Subject: Workplan Addendum
3800 San Pablo Avenue, Emeryville, California
ACDEH Fuel Leak Case: RO00002520; Global ID: T06019788682

Subject: Workplan Addendum
3800 San Pablo Avenue, Emeryville, California
ACDEH Fuel Leak Case: RO00002520; Global ID: T06019788682

Subject: Partial Work Plan Approval and Request for Work Plan Addendum; Fuel Leak Case No. RO00002520 (Global ID #T06019788682), Maz Glass; 3800 San Pablo Avenue, Emeryville, CA 94608

INITIAL SITE CONCEPTUAL MODEL
Maz Glass UST Site
3800 San Pablo Avenue
Emeryville, California

SITE PLAN

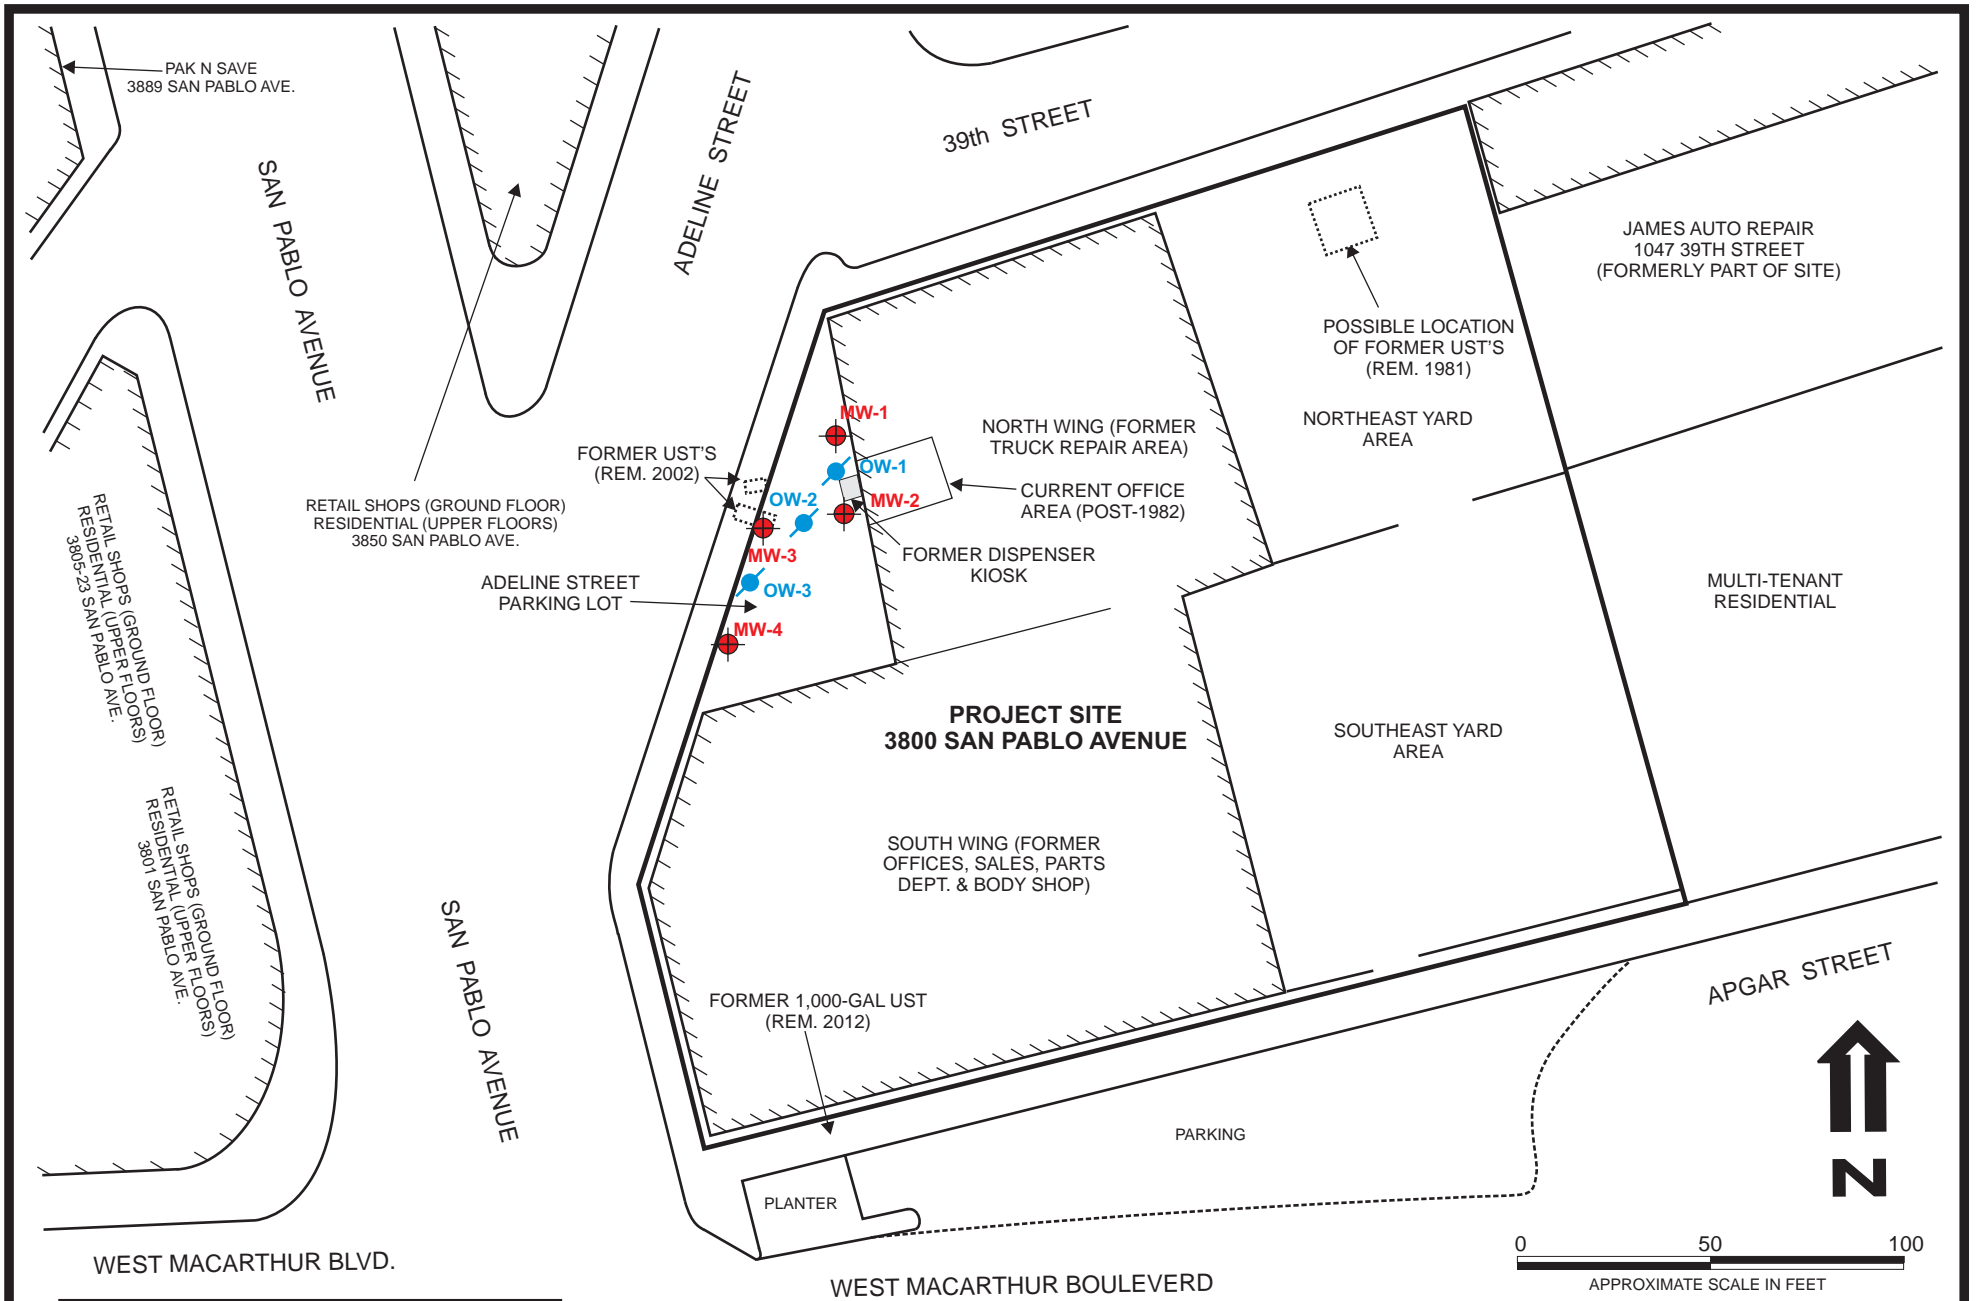
- b. **Site Vicinity Uses** - An aerial photographic figure to allow a determination of vicinity site uses.
- c. **Soil and Well Bore Details** - Submittal of all soil and well bores with PID and initial and static groundwater depths as discussed in meetings and as previously requested.

- b. **Site Vicinity Uses** –Figure 2 in the SCM shows site vicinity uses, particularly immediately downgradient (southwest) from the site.
- c. **Soil and Well Bore Details** – Soil and well boring logs previously submitted include only the data collected in the field at the time of drilling. Thus, missing ancillary field data (PID readings or initial/final groundwater depths, for instance) that were not collected cannot be added later. Ancillary data, such as PID readings and initial/final groundwater depths, are collected if possible, but not always, depending on exigent field conditions. Certainly and as always, we will attempt to obtain this ancillary data in the future.

**CROSS SECTION & UTILITIES
LOCATION MAP**
3800 SAN PABLO AVENUE
EMERYVILLE, CALIFORNIA

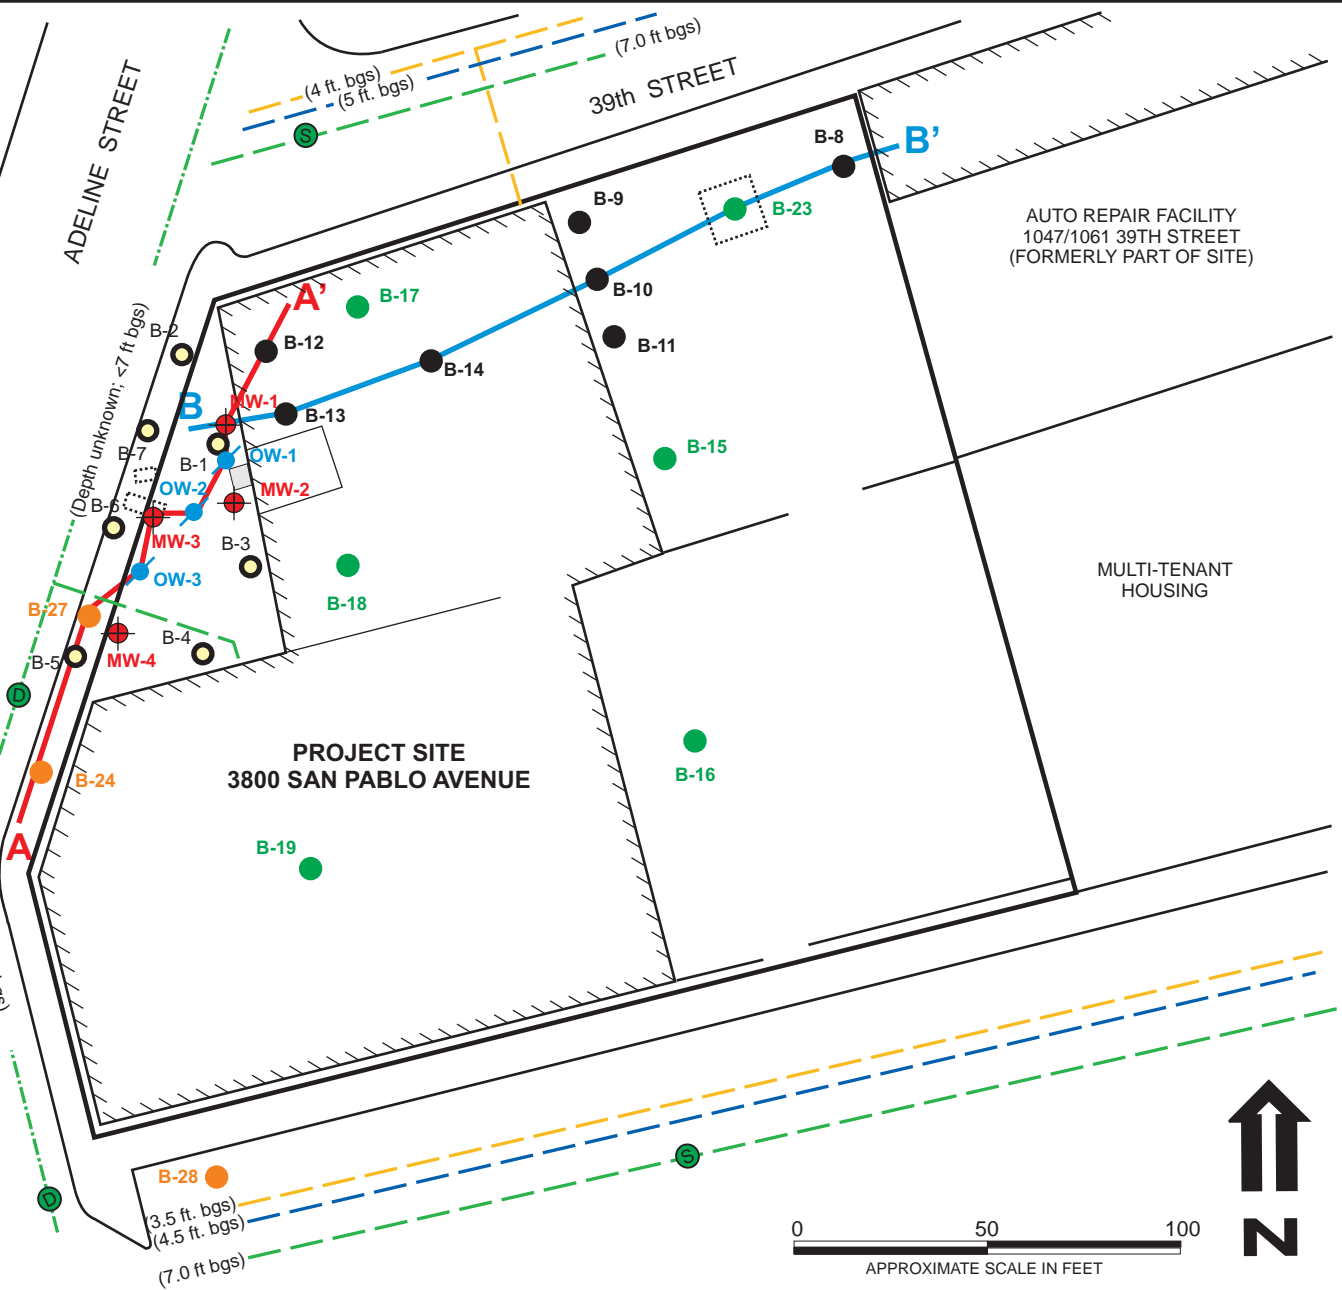
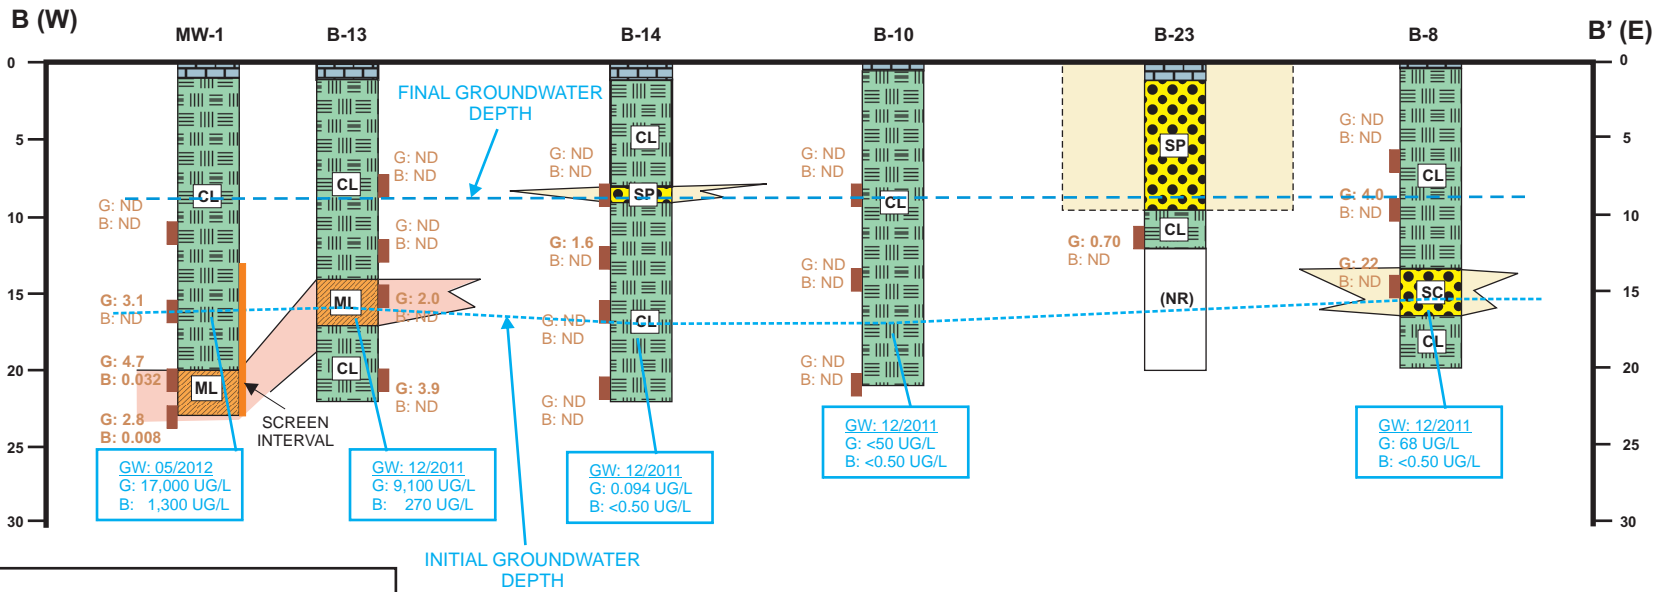
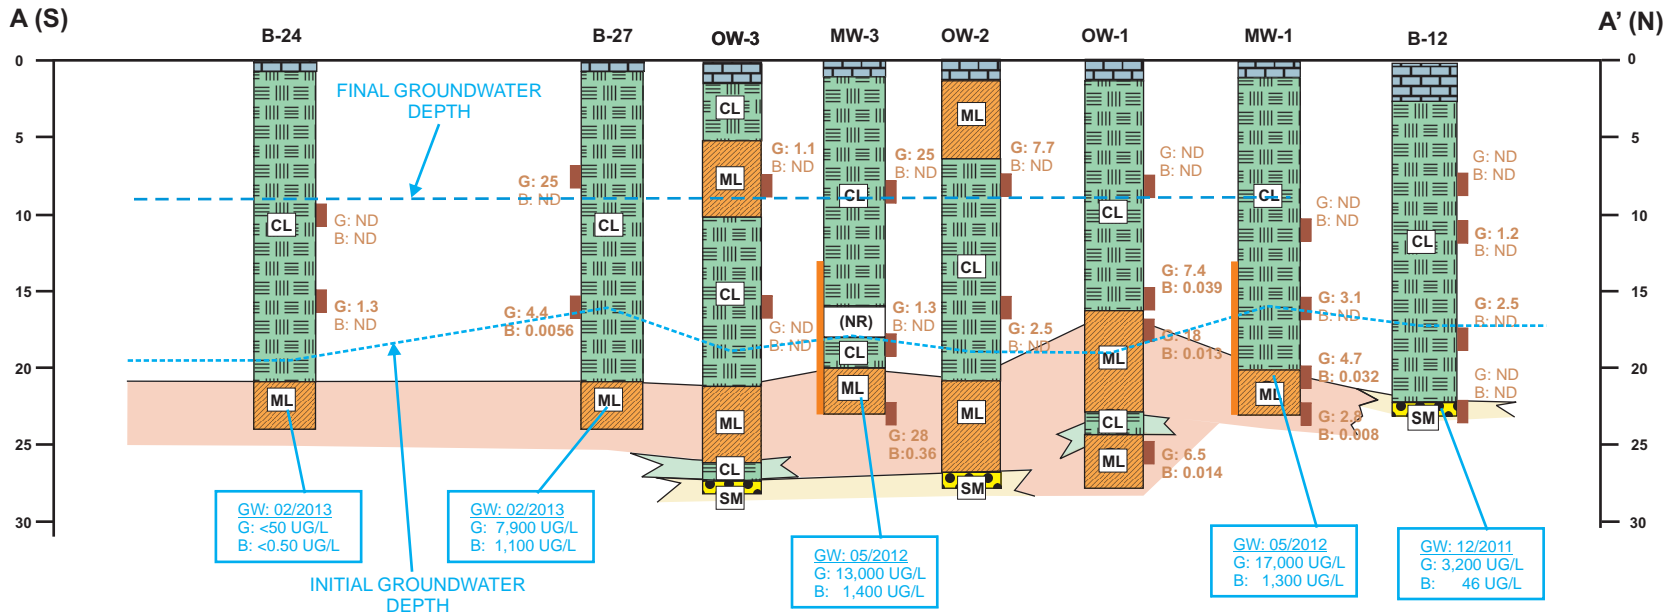
- **Preferential Pathway Study** - Submittal of a preferential pathway study (location and depth of utilities, and of vicinity water supply wells using Department of Water Resources (DWR) and the Alameda County Public Works Agency (ACPWA) resources) has been requested multiple times (November 16, 2012 and January 23, 2014) in directive letters. Utility information has been summarized, but not depicted in site figures which are useful in understanding potential bore location limitations or other considerations. The Geotracker Groundwater Ambient Watering and Assessment (GAMA) website has also been reviewed for water supply wells; however, as previously requested, DWR and ACPWA databases have not been. Because the databases of each agency and website are separate and different, it is appropriate to review each of these resources. Review of Figure 5 from the *East Bay Plain Groundwater Basin Beneficial Use Evaluation Report, Alameda and Contra Costa Counties, CA*, San Francisco Regional Water Quality Control Board, dated June 1999, indicates that this region of Emeryville has a high incidence of early, potentially unregistered, water supply wells (see copy attached). Please depict utilities on figures with the proposed locations of the borings. Please also depict water supply well locations on a figure and tabulate identified wells. ACEH recognizes that well construction details are confidential; however, well locations are not.

- **Preferential Pathway Study** – Underground utilities were mapped by a utility location subcontractor and both location and depths of identified utilities were included on the SCM on Figure 3. No utilities were found that extend below groundwater. In accordance with your letter, a more thorough well survey will be conducted as part of site closure activities.
- 2. **Groundwater Monitoring** – During the next groundwater monitoring event, groundwater samples from all site monitoring wells will additionally be analyzed for TPH-D, TPH-HO, SVOCs, VOCs, EDB, and EDC.
- 3. **Site Investigation Report** – A site investigation report will be submitted which addresses the requirements in the ACEH letter.

HISTORICAL GROUNDWATER HYDROCARBON RESULTS
 3800 SAN PABLO AVENUE
 EMERYVILLE, CALIFORNIA

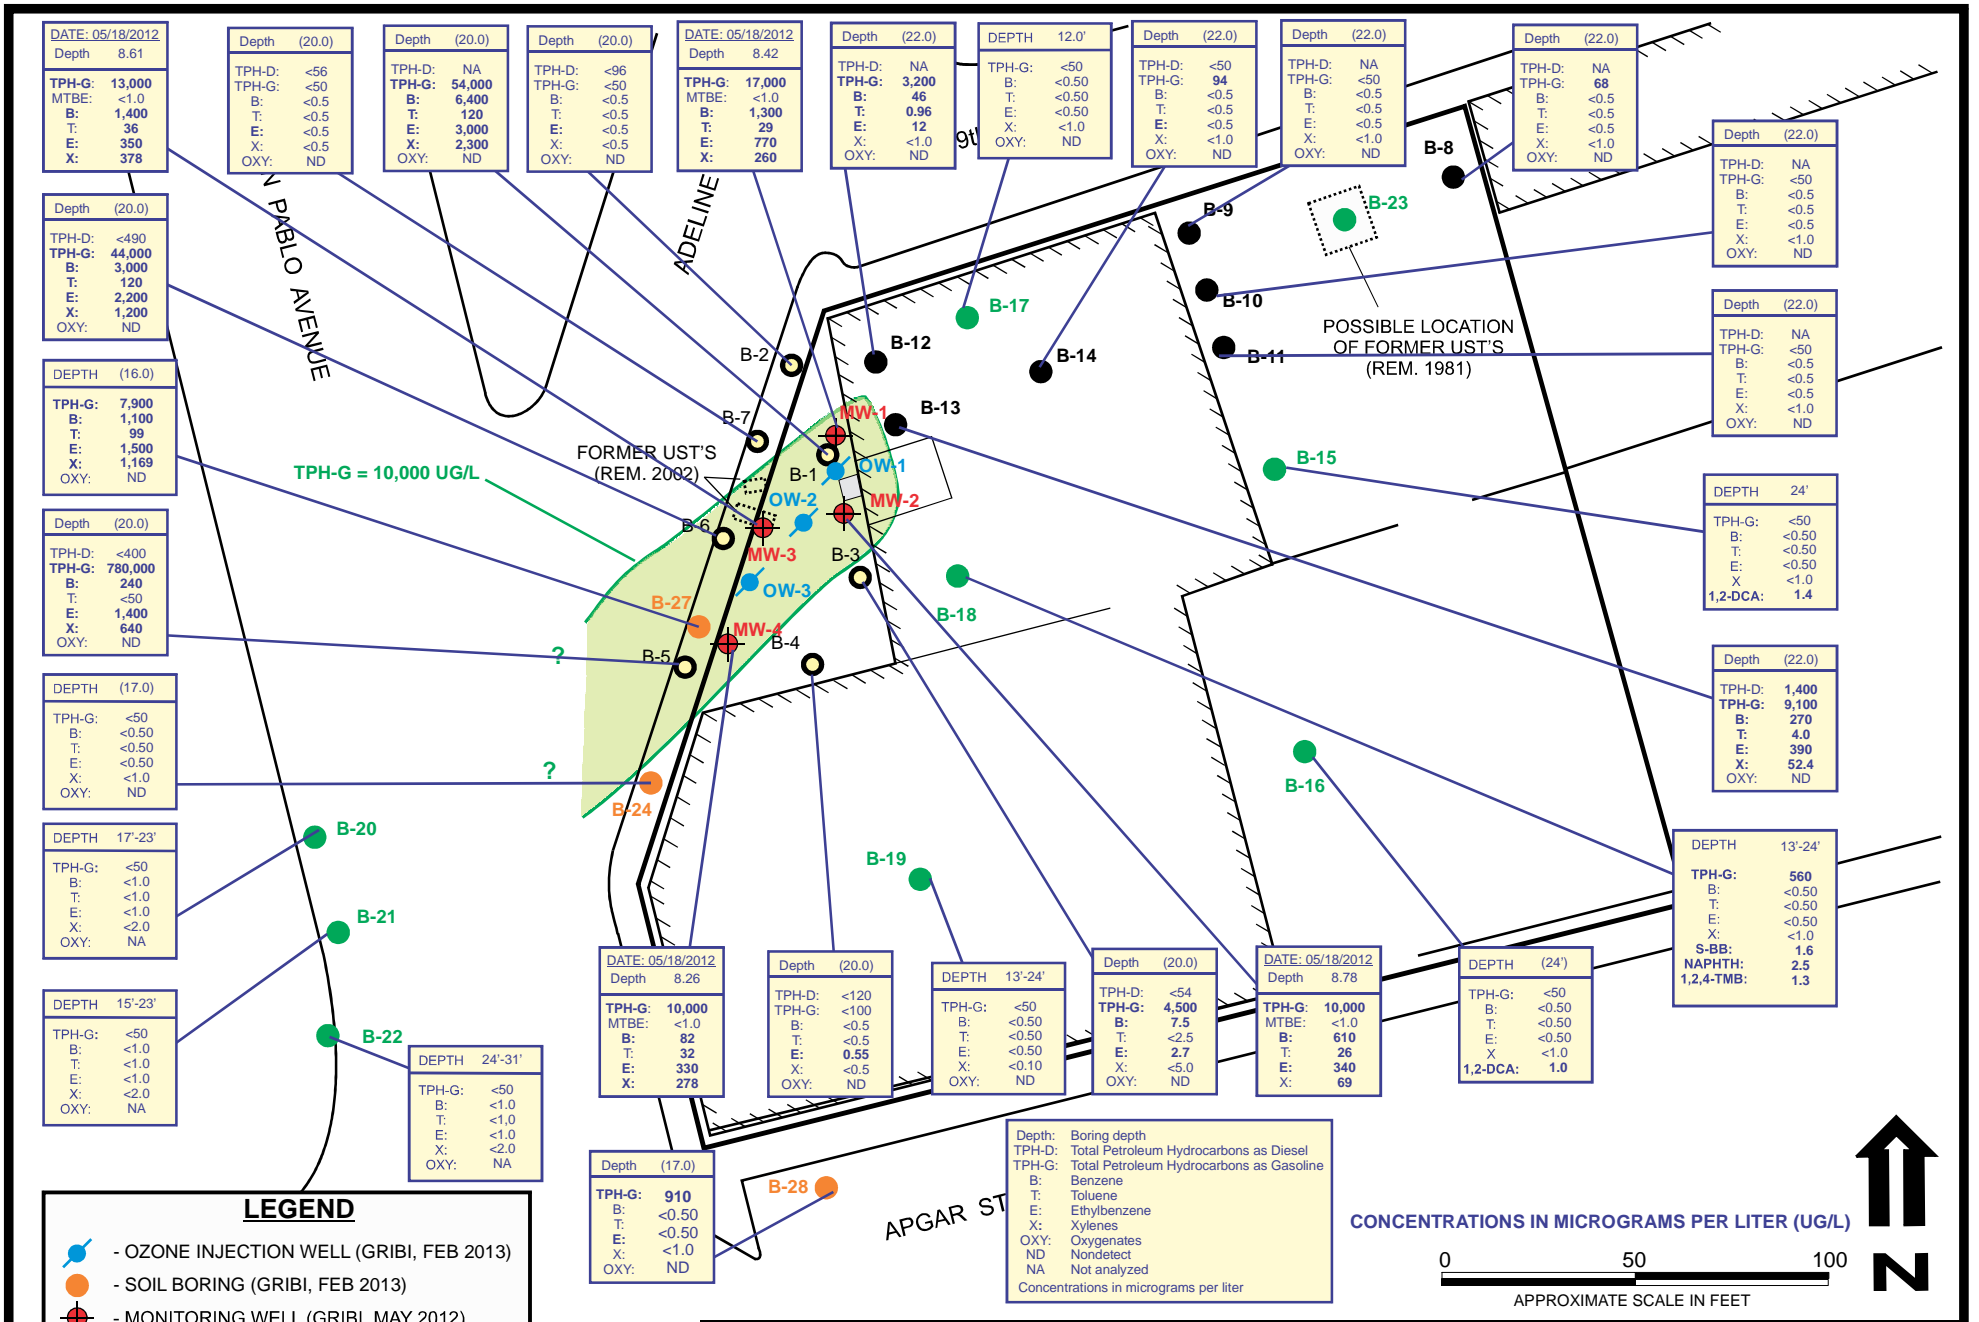
The work plan proposed the installation of two soil bores across San Pablo Avenue from the subject site in order to help define the extent of the soil and groundwater plume in this direction; however, due to the lack of submitted data and analysis as previously requested, ACEH is uncertain that this is the only groundwater plume direction that requires delineation.

- b. **Shallow Soil Characterization** – No change or additions requested by ACEH.
- c. **Groundwater Plume Delineation** – During our April 18, 2014 meeting with ACEH staff, we discussed our conclusion that, based on the large amount of groundwater data from borings and wells, groundwater samples showing nondetectable concentrations of gasoline constituents have been collected in all directions from the known source area, except to the west (see Figure 8 in the SCM).

Based on review of the data set, the hydrocarbon plume surrounding the known source area has been defined, except to the west across San Pablo Avenue. Thus, the data gaps workplan proposed two additional borings (borings B-29 and B-30) west across San Pablo Avenue. This is really the only direction that has not been investigated to non-detect.
